KOCH NITROGEN COMPANY LLC

**RE            Response to EPA November 21, 2012 Approval w/ Comment to the Phase II  
 RFI Work Plan Addendum: Tier II Soil Plan  
 Koch Nitrogen Company, LLC  
 Dodge City, Kansas  
 EPA RCRA ID No. KSD044625010**

**EPA 21 NOVEMBER 2012 COMMENTS  
AND KNC RESPONSES**

PROJECT:	FIGURE NO.	B-7
DATE: DECEMBER 2012	FILE NO.

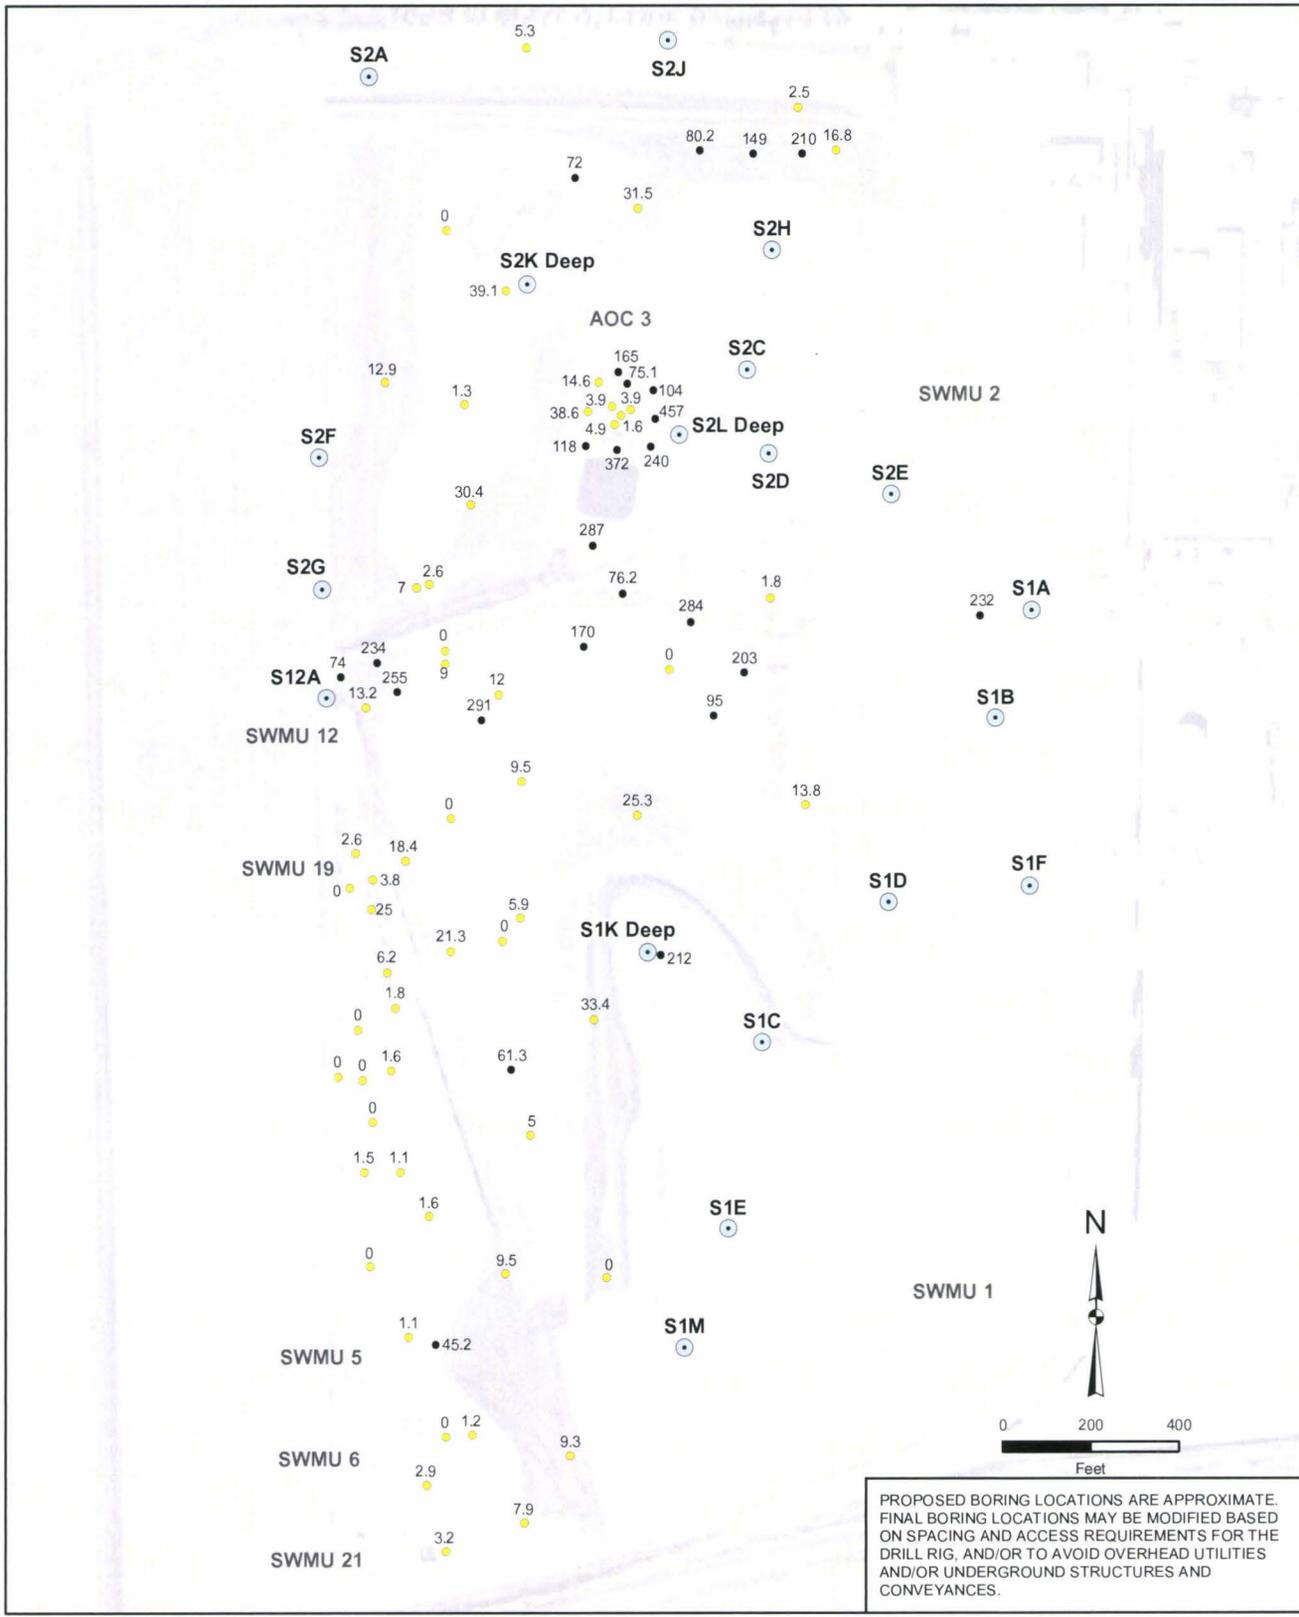
agreed to go all the way down. Please add to maps starting with B-7.
B-21 and B-22	Nitrate+Nitrite(as N)	Location S11E is missing from this figure. It was agreed to be located to the right of S11B, at the corner of the lime drying bed.
New Figure B-23	Nitrate+Nitrite(as N)	This figure does not show any sampling locations
C-4 and C-5	Total Chromium and Hexavalent Chromium	On the left side of this map, there is a green dot with 13,000 total chromium (hexavalent chromium not sampled). This location is only shown on these two maps, and that sampling location is not sampled after that. This location needs to be sampled for total and hexavalent chromium all the way down until non-detect to determine why this location is extremely high for total chromium

- **Figure B-5 and B-6 – Figures B-7 through B-13 (Attachment D) and Table 1 (Attachment E) have been revised to reflect this requested modification.**

PREPARED BY:		
 <small>KOCH NITROGEN COMPANY 11599 US HIGHWAY 50 - P.O. BOX 1337 DODDGE CITY, KS 67801</small>		
PROJECT.	FIGURE NO.	C-2
DATE. DECEMBER 2012	FILE NO.

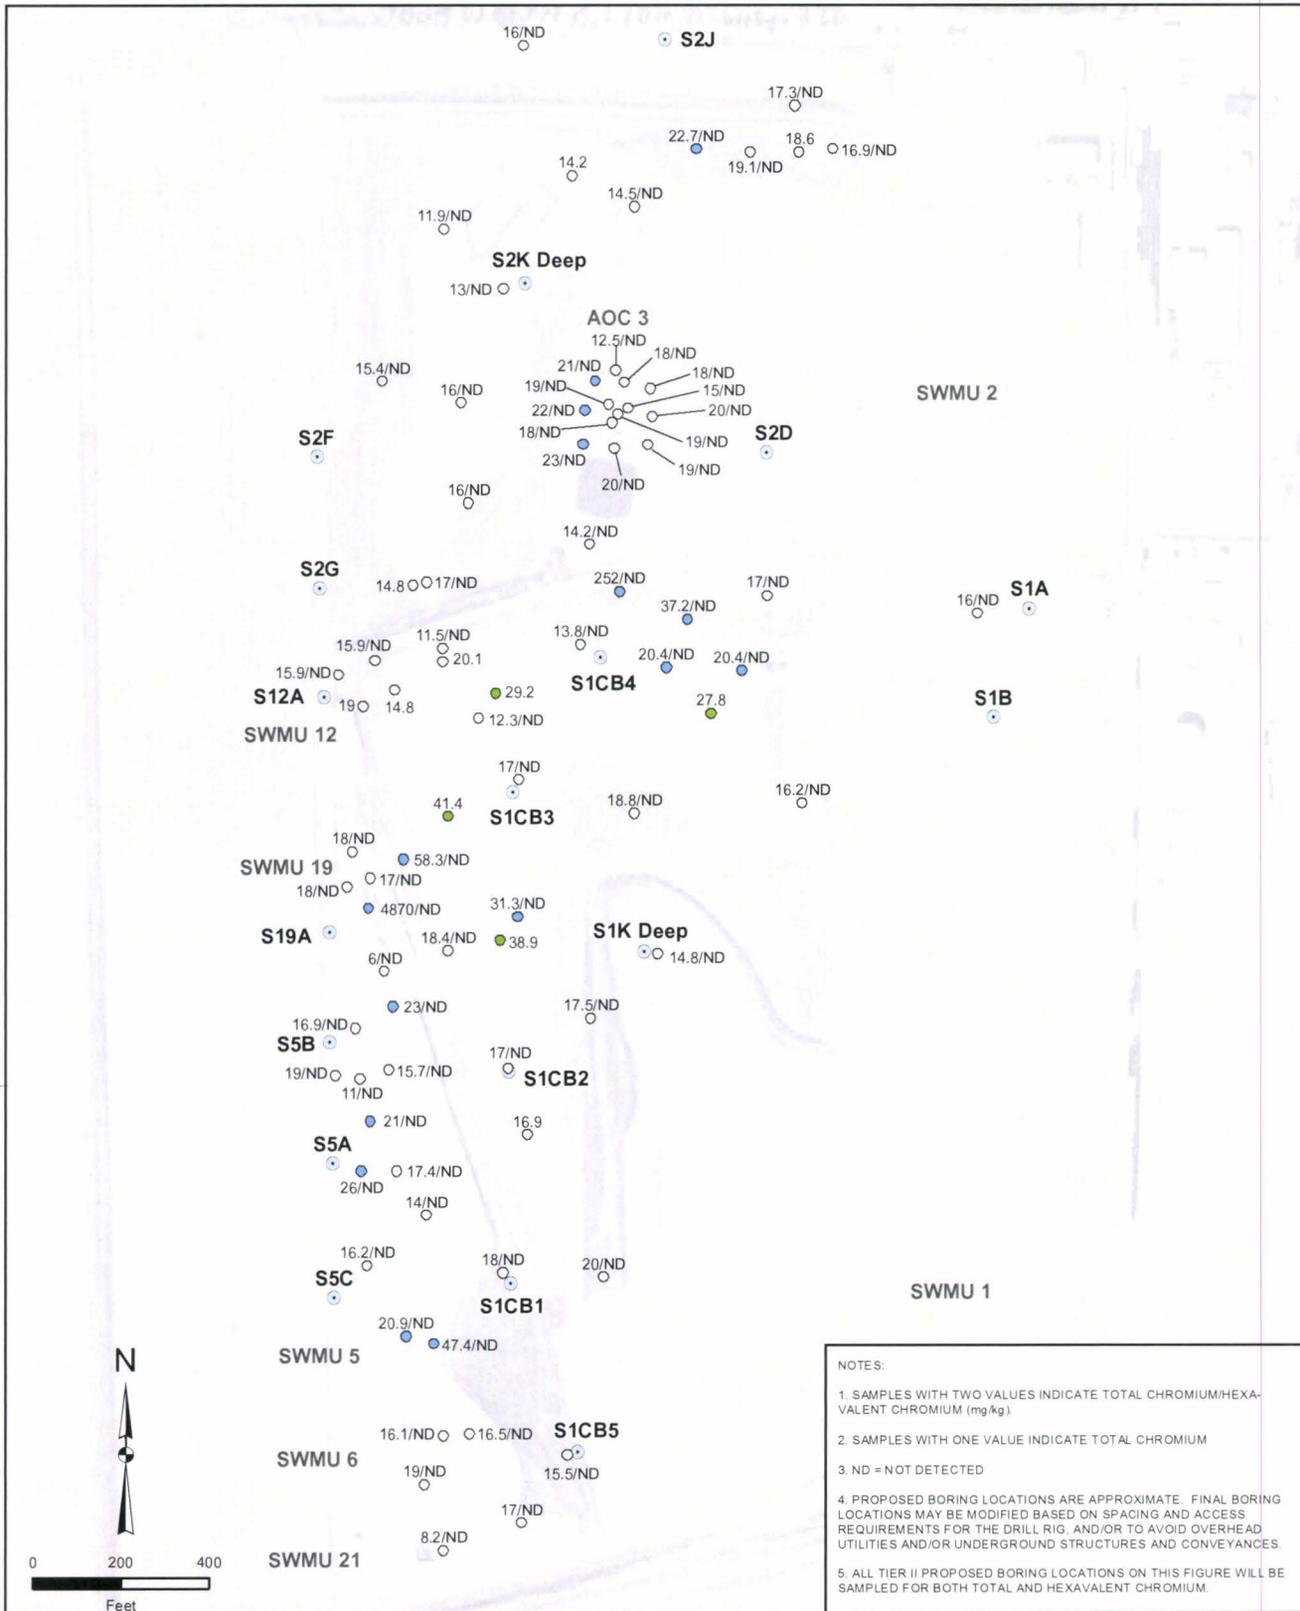
PM Comment 3 - Section 3.0 Chromium Soil Sampling, Page 5, Third Paragraph, Last Sentence: The last sentence states, "These borings will be advanced 4 ft bgs." Four (4) feet bgs will not characterize the vertical and horizontal extent of the hexavalent chromium. In all locations where hexavalent chromium was previously detected and in addition spots check to account for the lower RSL for hexavalent chromium, KNC must define the vertical and horizontal extent of contamination. Please revise this section and the appropriate Figures, and submit replacement pages.

**After a review of the hexavalent chromium maps, specifically Figure C-2 in Appendix C, an additional confirmation boring to 10 ft bgs (S1CB5) is proposed in the southern**

portion of the west study area. Modifications to Figures C-1 through C-6 (Attachment D) and the tables (Attachment E) are provided to document these changes as replacement pages.

PREPARED BY:		 KOCH NITROGEN COMPANY 11559 US HIGHWAY 50 - P.O. BOX 1307 DODGE CITY, KS 67801	
PROJECT NO.	FIGURE NO.	F-11	
DATE: DECEMBER 2012	FILE NO.

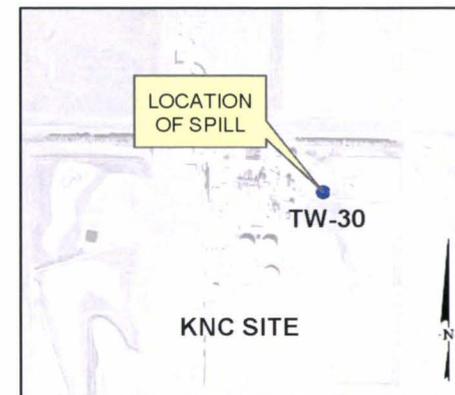
PM Comment 5 – *Section 6.0 Previously Reported Spills of Recovery Well Water, Page 8: This section describes the previously reported spills. In accordance with KNC’s October 5, 2012 notification of approximately 400 gallons of recovered groundwater from the recovery well piping/header near TW-30. In accordance with the KNC’s Part II Permit, Permit Condition C.4, KNC has notified EPA, and the EPA has determined that this spill/release will need to be investigated. Please add this new spill location to this section (6.0) and show its location on the appropriate Figure. Please revise the appropriate section, figures, tables, and appendices.*

**Response: Comment noted. An additional sentence has been added to page 8 (Attachment B) that reads, “In accordance with EPA’s 21 November 2012 approval letter, the 5 October 2012 spill previously reported to EPA will be assessed under this program, as summarized in Table 2 and depicted in Figure F-11.” Additional information on this spill and the proposed sampling program are provided in revised Tables 1 and 2 (Attachment E), and the proposed sampling program for this area is depicted on new Figure F-11 (Attachment D).**
